NL-09-0587

Joseph M. Farley Nuclear Plant – Units 1 and 2
Response to Request for Additional Information Regarding
Proposed Relief Requests for the Third ISI Interval
(TAC Nos. MB9742 through MC9751)

**Response to Request for Additional Information Regarding
Proposed Relief Requests for the Third ISI Interval**

Weld No. ALA2-4540-32-RI
Figure 1 (RAI 2.2)

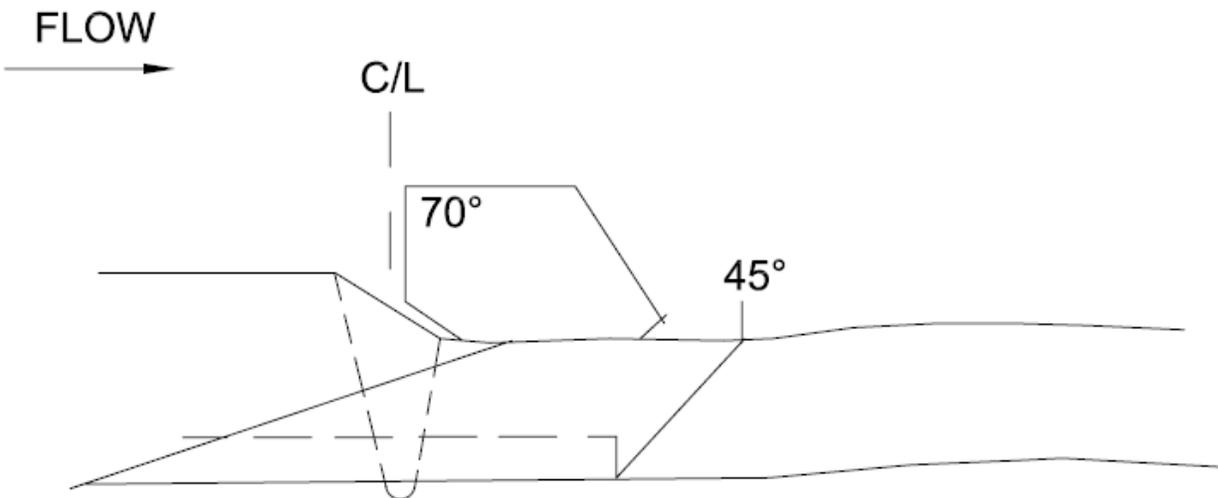
The licensee has requested relief from the 100 percent ASME Code volumetric examination requirements for piping Weld ALA2-4540-32-RI, as defined by the FNP Unit 1, Risk-Informed Inservice Inspection Program. The basis for the RR is that 100 percent of the ASME Code-required inspection volume cannot be obtained because of component configuration and access restrictions.

The licensee's submittal states that the subject weld root area was interrogated with both 45 and 70-degree shear waves (S-waves) looking for circumferential cracking. The licensee's submittal further states that examinations were performed after the implementation of Appendix VIII (performance demonstration), and consisted of single-sided examinations from the pipe side of the weld.

Confirm that subject Weld ALA2-4540-32-RI was examined only using 45 and 70-degree S-wave techniques. If only S-wave techniques were used to examine the stainless steel weld, please explain why longitudinal wave (L-wave) examination techniques were not used as part of a best effort examination. The L-wave method has been shown capable of detecting planar (DP) inside diameter surface-breaking flaws on the far-side of wrought stainless steel welds. Recent studies recommend the use of both S-waves and L-waves to obtain the best detection results, with minimum false calls, in austenitic welds.

Weld ALA2-4540-32-RI was examined with a 0.25-inch diameter, 45-degree shear wave, 2.25 MHz transducer. An additional 0.25-inch diameter, 70-degree shear wave, 2.25 MHz transducer was used to examine the weld. All procedure requirements were met, with a maximum of 50% Code coverage claimed, since it was a single-sided examination. Figure 1 of NRC RAI 2.2 shows the limitations for weld ALA2-4540-32-RI.

The reason for not using the L-Wave technique for weld ALA2-4540-32-RI is because it is an austenitic weld with a nominal wall thickness of 0.46-inch. The procedure used to examine wrought austenitic piping weld configurations after the implementation of Appendix VIII was the SNC Supplement 2 procedure that utilized generic procedure PDI-UT-2. PDI-UT-2 requires that, when accessibility is limited to a single side in materials with a nominal wall thickness equal to or less than 0.50-inch thick, a 2.25 MHz, 70-degree shear wave search unit shall be used for the detection and length sizing of flaws on the far side of the weld. When the material

50% Coverage achieved based on one-sided access

Weld ALA1-4300-26RDM-RI
Figure 1 (RAI 2.4)

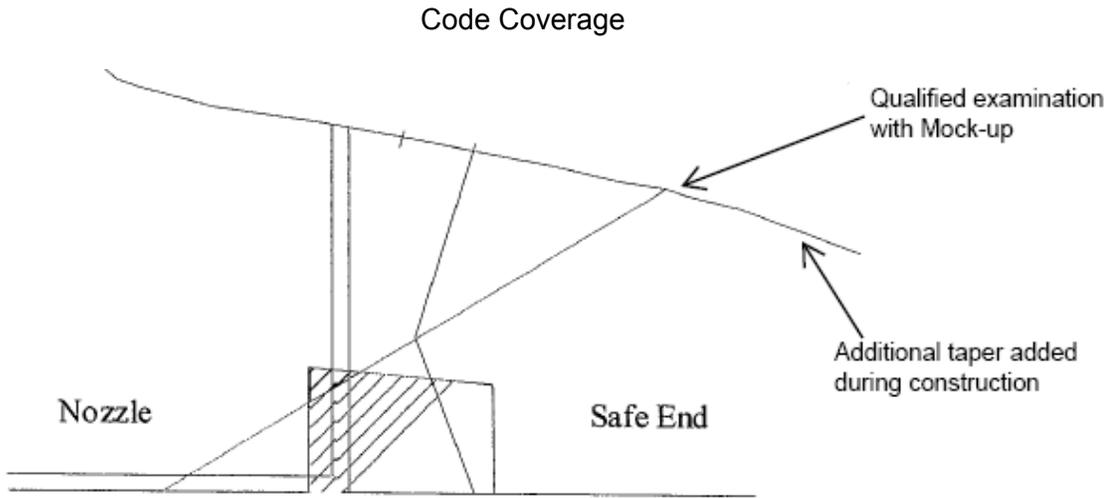
RR-65 applies to primary system safe-end-to-nozzle dissimilar metal welds ALA1-4300-26ROM-RI [*sic*], and ALA1-4300-27ROM-RI [*sic*] on a steam generator at FNP Unit 1. The NRC staff notes that Supplement 10 demonstrations are single-side (from the safe end) access qualifications. It is unclear why the licensee cannot examine the full ASME Code volume by using multiple ultrasonic techniques from the safe end side of these welds.

Please describe the ultrasonic inspection techniques that were used to examine the subject dissimilar metal welds and confirm that all of these techniques were demonstrated during qualification to Supplement 10 of the ASME Code, Section XI, Appendix VIII. Include discussion as to whether site-specific demonstrations occurred, and provide any technical justifications or reports resulting from this site-specific activity

The sketches provided with RR-65 do not illustrate the amount of weld that was inspected or what inspection angle(s) were used during the ultrasonic examination. Please submit information in the form of sketches or technical descriptions that illustrate the inspection techniques (scan angles) and the amount of ASME Code coverage that was obtained by each of the techniques (scan angles) applied.

See Figure 1 of NRC RAI 2.4 to determine the amount of weld that was examined for weld ALA1-4300-26RDM and see Figure 2 of NRC RAI 2.4 to determine the amount of weld that was examined for weld ALA1-4300-27RDM.

1.90 square inches achieved with 34 degree exam angle- 52%

.16 square inches achieved with 45 degree exam angle- 4.4%

Total coverage obtained = 52.1%

Figure 1 (RAI 2.5)

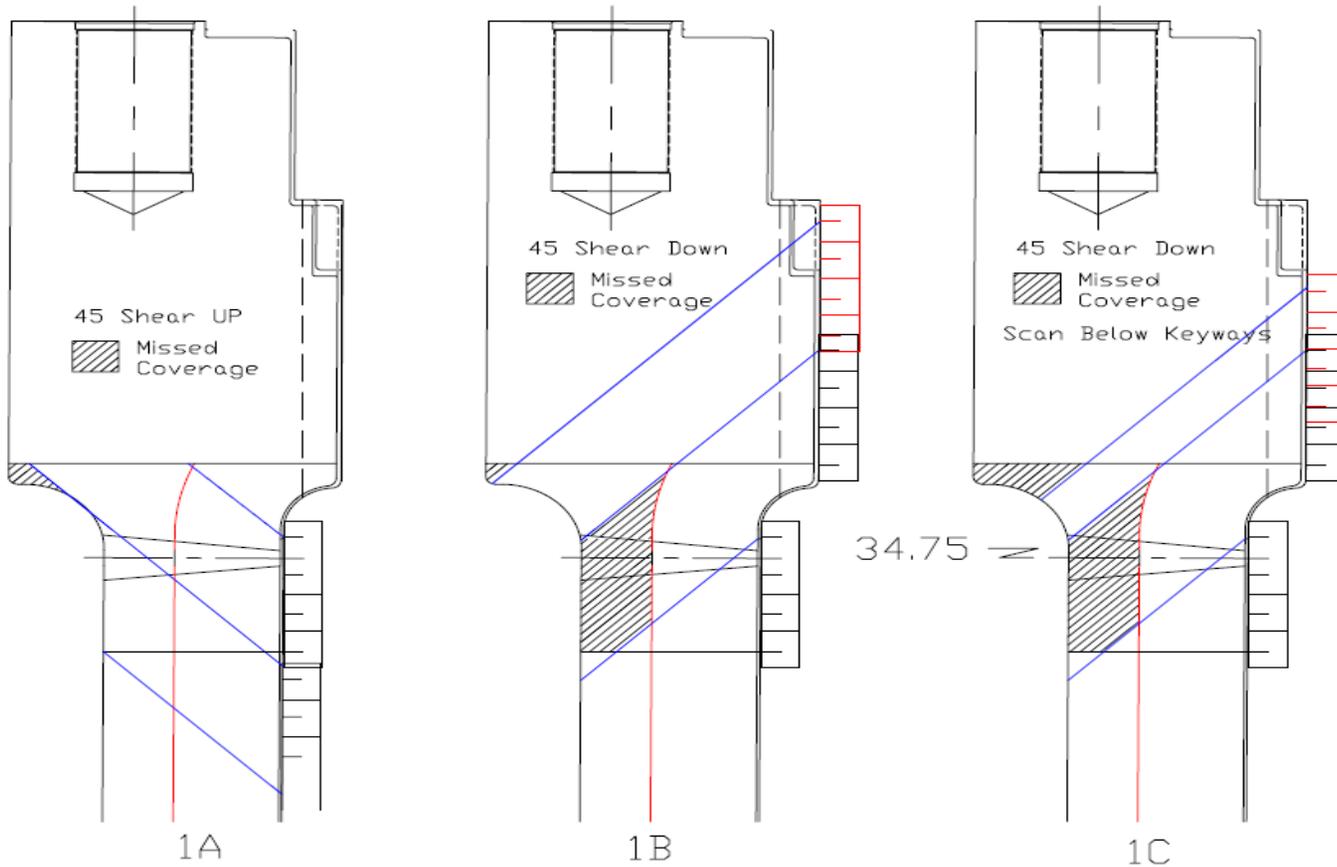
While the technical descriptions provided in RR-66 and RR-68 list the general bases for examination limitations, the descriptions do not state how the listed bases limit the examinations. As an example, Table RR-66 states that weld ALA1-1100-1 was limited due

to the flange configuration, keyways and irradiation specimen slots. This does not state how or why the flange configuration, or other appurtenances, limits the examination. For each of the welds in RR-66 and RR-68, provide sketches or sufficient technical descriptions so that the reasons for the impracticalities are clear.

Region 1 - The 45-degree shear transducers were configured to examine from the outside diameter (OD) surface of the reactor vessel to 0.6T (where T is the thickness). Detail 1A in Figure 1 shows the missed Region 1 coverage when scanning from below the transition. Detail 1B in Figure 1 shows the missed Region 1 coverage when scanning from above the transition when there was no interference from the four keyways. Detail 1C in Figure 1 shows the missed Region 1 coverage when scanning from above the transition in the four keyway areas.

- Region 1 – As shown in detail 1a of Figure 1, the examination from below the weld covered the examination volume except for a very small volume on the outside which was missed due to the OD taper transition. Additionally, as shown in detail 1b of Figure 1, the examination from above the weld (when there was no interference from a keyway) covered a small portion of the volume missed by the scan from below. However, as shown in detail 1c of Figure 1, when there is interference due to the keyways, there is no appreciable extra coverage from above. It was determined that single-sided coverage exceeded 95%.

Weld ALA1-4103-4
Figure 1 (RAI 2.6)

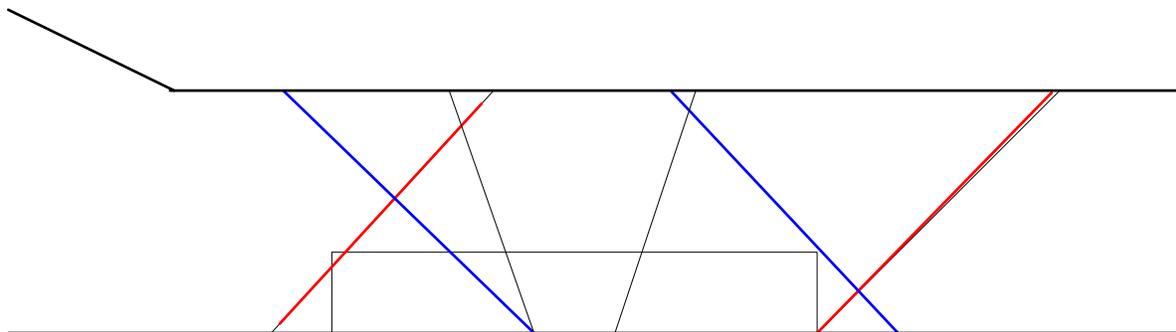
The licensee has requested relief from the 100 percent ASME Code volumetric examination requirements for ASME Code, Class 1 Category B-J austenitic piping weld ALA1-4103-4. The basis for the RR is that 100 percent of the ASME Code required inspection volume cannot be obtained because of the component configuration and an access restriction.

Confirm that this weld was examined using both S-wave and L-wave techniques. As stated in Section 2.2.1 above, the L-wave method has been shown capable of ID surface-breaking flaws on the far-side of wrought stainless steel welds.

Weld ALA1-4103-4 was examined prior to the implementation of Supplement 2 of Appendix VIII. This weld was examined using the requirements of Appendix III of the 1989 Edition of ASME Section XI, which requires that the examination volume receives two-directional coverage. A 45-degree and 60-degree shear wave was used with the 45-degree being the primary angle based on Paragraph III-4410 of Appendix III. Referencing Figure 1 below (Figure 1 was drawn from a field sketch), when scanning from the pipe side for detection of circumferentially-oriented flaws there were no limitations and the coverage was 100%. However, when scanning from the valve side for detection of circumferentially-oriented flaws, the valve taper prevented the transducer from being moved back to the extent necessary to pass the sound beam through the complete valve side examination volume. As a result, only about 60% of the volume was examined from the valve side, as depicted by the blue lines. Therefore approximately 80% of the examination volume received two-directional coverage and 20% received one-directional coverage when scanning for circumferentially-oriented flaws. When scanning for axially-oriented flaws there were no scanning limitations identified. There were no requirements to use an L-wave method to look for planar ID surface-breaking flaws on the far-side of the weld at the time these examinations were performed.

Weld ALA2-4103-2-RI
Figure 1 (RAI 2.7)

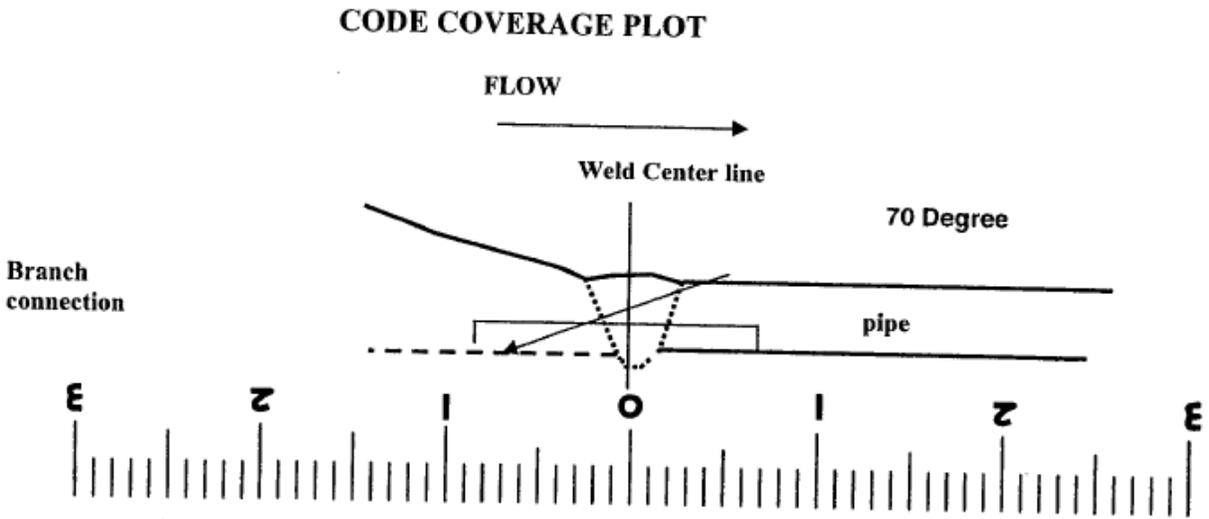
The licensee's submittal summarizes limited examinations performed during the third 10-year ISI interval, and provides calculated coverage for each component. However, in order to show the impracticality of examining 100 percent of the ASME Code required volumes or surface areas, the licensee's submittal provides only "typical" figures that do not describe or depict the specific limitations for each weld listed in Table RR-61.

Please submit detailed and specific information to support the basis for each limited examination in RR-61, and, therefore, demonstrate impracticality. Include descriptions (written and/or sketches, as necessary) of the interferences to applied nondestructive examination (NDE) techniques. As applicable, describe NDE equipment, show accessibility limitations, and discuss whether alternative methods or advanced technologies could be employed to maximize ASME Code coverage.

Weld Number	Description	Primary Beam Angle	Secondary Beam Angle	Basis For Examination Limitations
APR2-4103-2-RI	3" Branch Connection to Pipe	45 ⁰ Shear	70 ⁰ Shear	This thin-wall piping weld was selected as part of the risk-informed ISI program because of previous high vibration issues. The nominal pipe wall thickness is 0.3-inches. The examination was limited due to the branch connection and weld crown configuration as shown in Figure 1. Because of the thin-wall pipe and vibration issues it was not deemed appropriate to remove the reinforcement provided by the weld crown. A 70-degree Shear wave examination was performed to increase coverage. No other actions were considered as a practical means to appreciably increase the coverage.
APR2-4103-5-RI	3" Elbow To Valve	45 ⁰ Shear	70 ⁰ Shear	This thin-wall piping weld was selected as part of the risk-informed ISI program because of previous high vibration issues. The nominal pipe wall thickness is 0.3-inches. The examination was limited due to the valve taper and weld crown configuration as shown in Figure 2. Because of the thin-wall pipe and vibration issues it was not deemed appropriate to remove the reinforcement provided by the weld crown. A 70-degree Shear wave examination was performed to increase coverage. No other actions were considered as a practical means to appreciably increase the coverage.

Weld ALA2-4503-23-RI
Figure 1 (RAI 2.8)

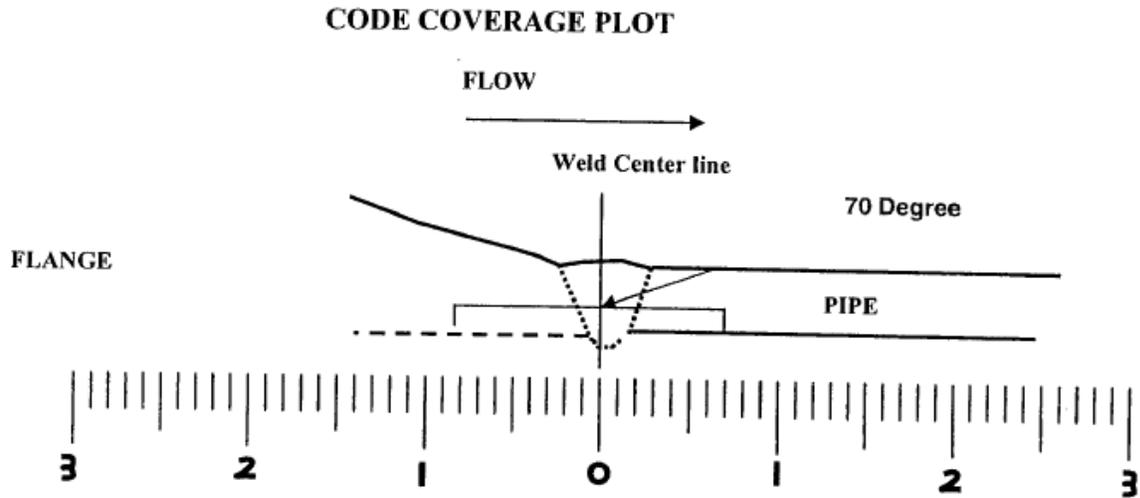
The licensee has requested relief from the 100 percent ASME Code volumetric examination requirements for piping welds, as defined by the FNP, Unit 2, Risk-Informed ISI Program. The basis for the request for relief is that 100 percent of the ASME Code-required inspection volume cannot be obtained because of component configuration and access restrictions.

The licensee's submittal states that the subject weld root areas were interrogated with 45-degree S-wave looking for circumferential cracking. The licensee's submittal further states that examinations were performed after the implementation of ASME Code, Section XI, Appendix VIII (performance demonstration), and consisted of single-sided examinations from the pipe side of the welds.

Confirm that the subject welds were examined only using 45-degree S-wave techniques. If only S-wave techniques were used to examine the stainless steel welds, please explain why L-wave examination techniques were not used as part of a best effort examination. As stated in Section 2.2.1 above, the L-wave method has been shown capable of ID surface-breaking flaws on the far-side of wrought stainless steel welds. Recent studies as noted in Section 2.2.1 of this RAI recommend the use of both S-wave and L-waves to obtain the best detection results, with minimum false calls, in austenitic welds.

Welds APR2-4503-23-RI and APR2-4503-34-RI have a nominal wall thickness less than 0.5-inch thick. These welds were examined with both a 45-degree shear wave and a 70-degree shear wave. All procedure requirements were met, with a maximum of 50% Code coverage claimed, due to single-side examination.
